WCAP-14572
Revision 1-NP-A

**Westinghouse Owners Group
Application of Risk-Informed
Methods to Piping Inservice
Inspection Topical Report**

For this safety evaluation, the NRC staff reviewed the WOG RI-ISI methodology, as defined by WCAP-14572, Revision 1, and its Supplement 1, with respect to the guidance contained in RG 1.178 and Standard Review Plan (SRP) Chapter 3.9.8 (Ref. 6) which describes the acceptable methodology, acceptance guidelines, and review process for proposed plant-specific, risk-informed changes to ISI programs for piping components. Further guidance is provided in RG 1.174 and SRP Chapter 19.0 (Ref. 7) which contains general guidance for using Probabilistic Risk Assessments in risk-informed decision-making.

Figure 4-5 *Uncertainties in Leak Probabilities for Stainless Steel Fatigue Calculated by PC-PRAISE (Khaleel and Simonen 1998)*

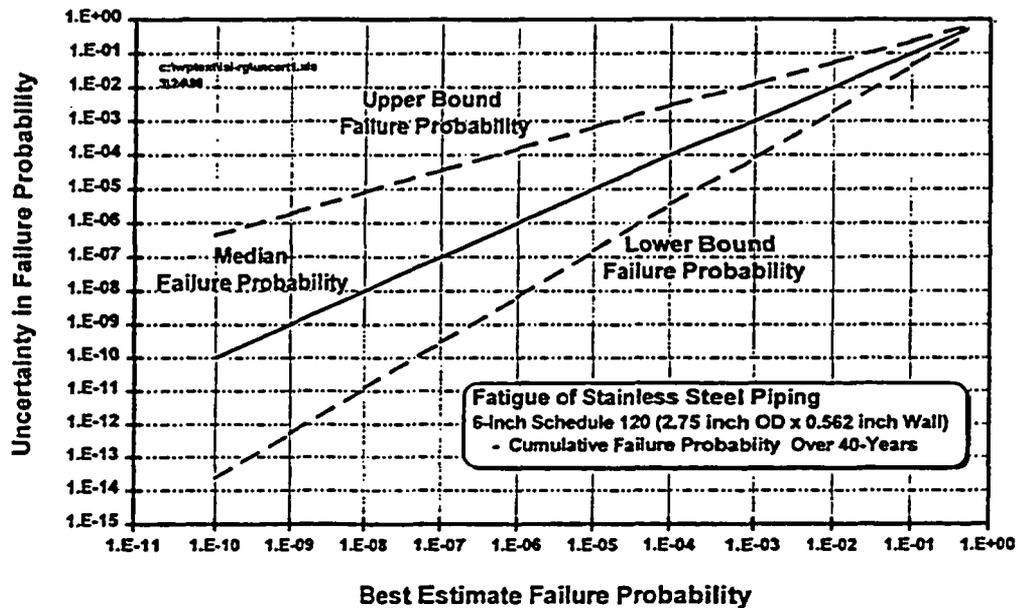
“A sensitivity study using pc-PRAISE (Harris, Dedhia and Lu 1992) on the effect of uncertainties was recently completed by ASME Research Task Force member Fred Simonen and Moe Khaleel of Battelle Pacific Northwest Laboratory. Figure 4-5, taken from this study (Khaleel and Simonen 1998), shows that *the 99% uncertainty bounds on a typical pc-PRAISE (Harris, Dedhia and Lu 1992) calculation of leak probability decreases as the value of leak probability increases. These uncertainty bounds should be higher than the corresponding uncertainty bounds on a typical leak probability calculated with the revised SRRA software. This is because many of the uncertainties not directly evaluated by pc-PRAISE, such as that on cyclic stress range, are already included in the standard SRRA software input (see Table 3-8).*”

Figure 4-5 on page 52 of WCAP-14572, Revision 1, Supplement 1, will be replaced with that on the following page.
